SENENICH PROPELLER CO., INC.

SERVICE BULLETIN SB2019-02A

SUBJECT: Inspection of adjustable pitch hubs for cracks

Figure 1. Cracks start near pitch marks and grow outwards.

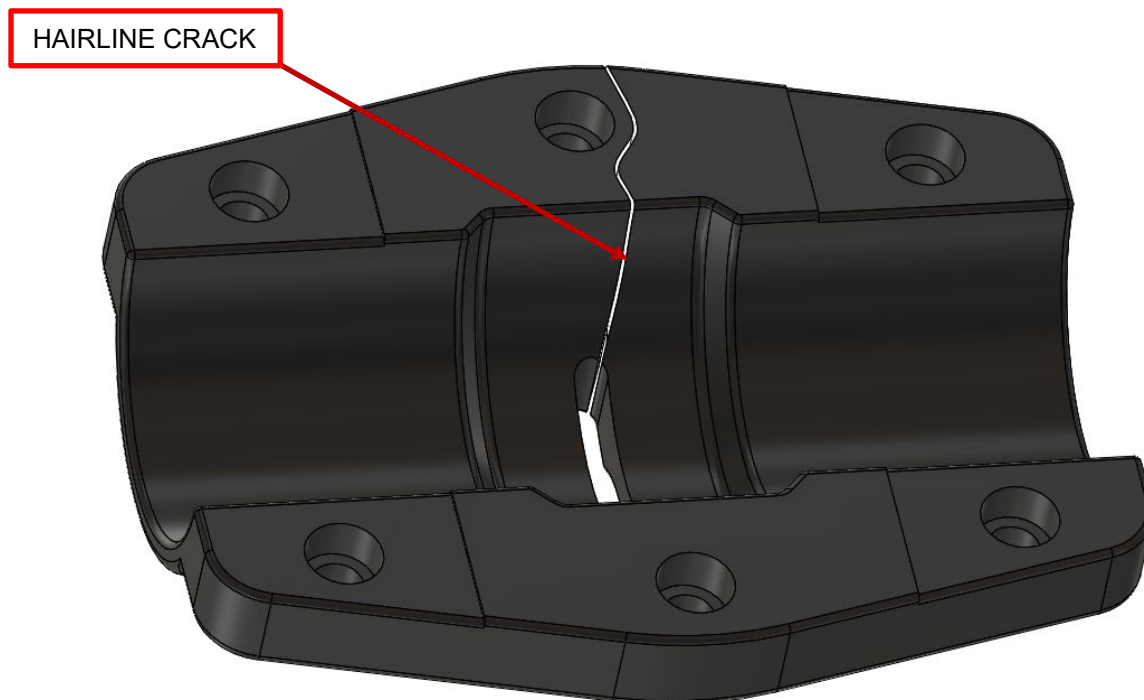
- The hub cracks typically start at or near the pitch cartridge slot on the sides of the central hole, and grow outwards towards the hub sides. They are hairline cracks which are very difficult to see with the naked eye. Refer to Figures 1 & 2 for crack location.

- Using very good lighting and a 10x magnifying glass, inspect the inside of the pitch cartridge slot in the hub cover next to the pitch marks.
- The hub cover must be removed from the propeller assembly for thorough inspection inside the pitch cartridge slot. *Inspection of the hub exterior is not adequate.*

- Notify Sensenich of any crack occurrences and return affected hub for evaluation.
- Inspect affected hub for cracks every 50 hours or annually, whichever comes first.

Figure 2. Unattended cracks may progress to edges of hub cover half.

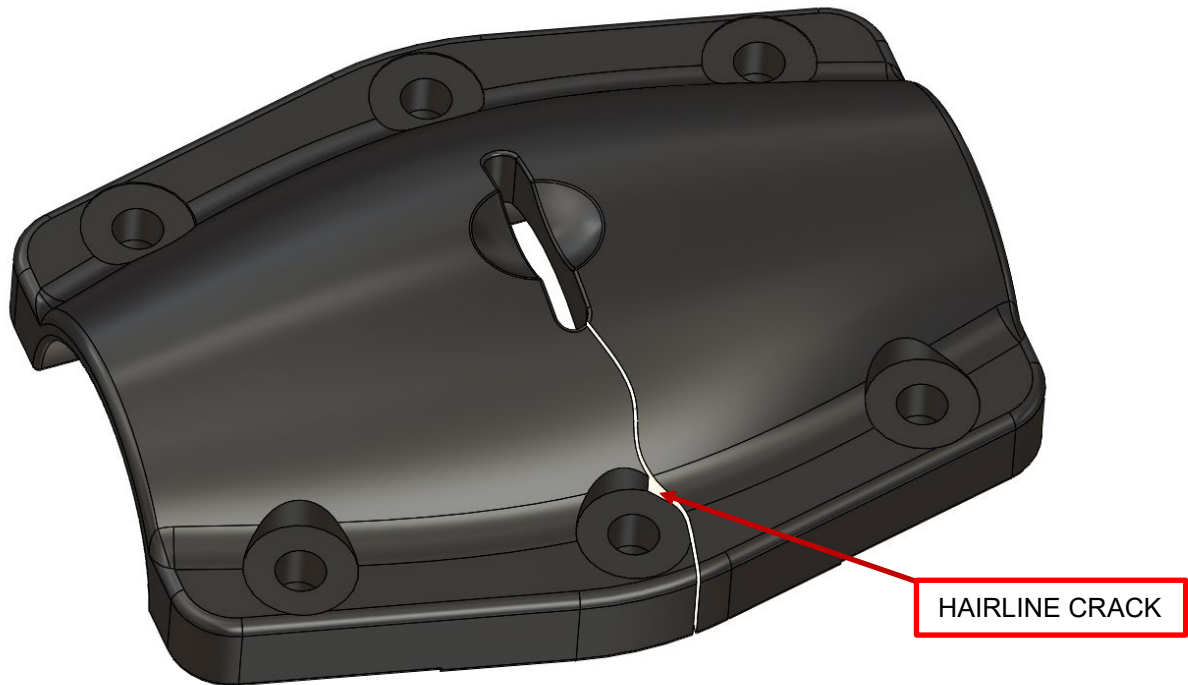
- The occurrence, if unattended, could result in the hub cover half cracking completely across.
- To date, there have been no inflight blade separations but the location of crack growth necessitates immediate inspection.
